Description of design in Design Freeze Document
Link to CAD Model

Minor Changes Made from Design Freeze Documentation

**Orthographic Views** (Front, Left, Back, and Bottom)

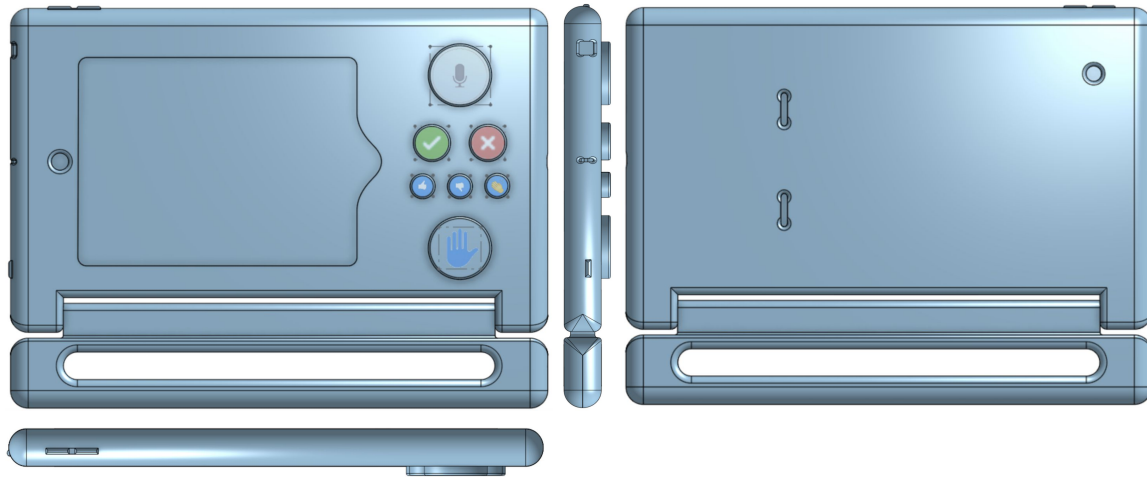
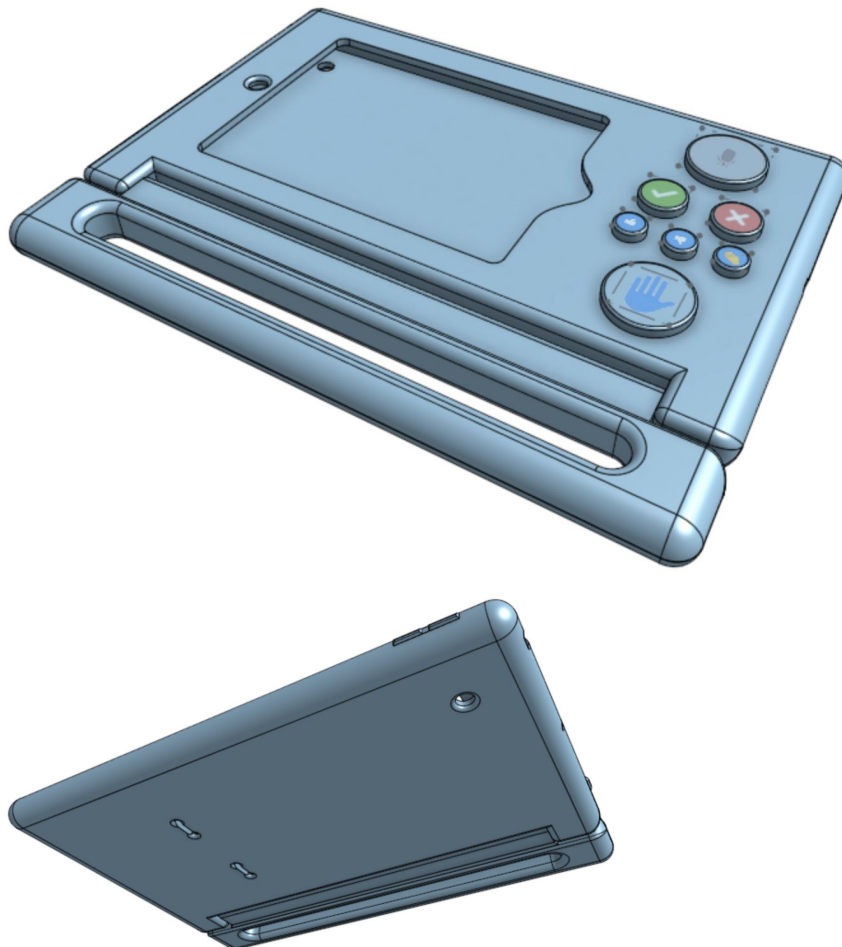
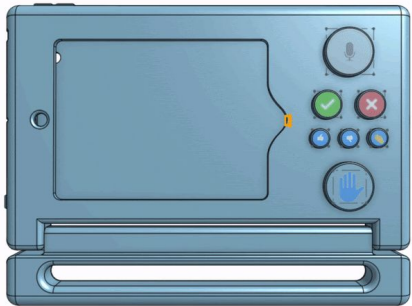
- As discussed when reviewing the design freeze documentation, a hole was added on the bottom for the back facing camera.

- Forgot to add a lightning connector plug, showing how the ipad connects to the button module once placed inside the rubber case.

- The layout of buttons on the iPad was in the opposite direction of the way it should be (eg. the iPad's volume buttons would've been where the hinge/kickstand is), so the design was flipped, having the iPad placed into the device leftwards, and the module with buttons is on the right. Flipping the design didn't change anything else about how the device would function.
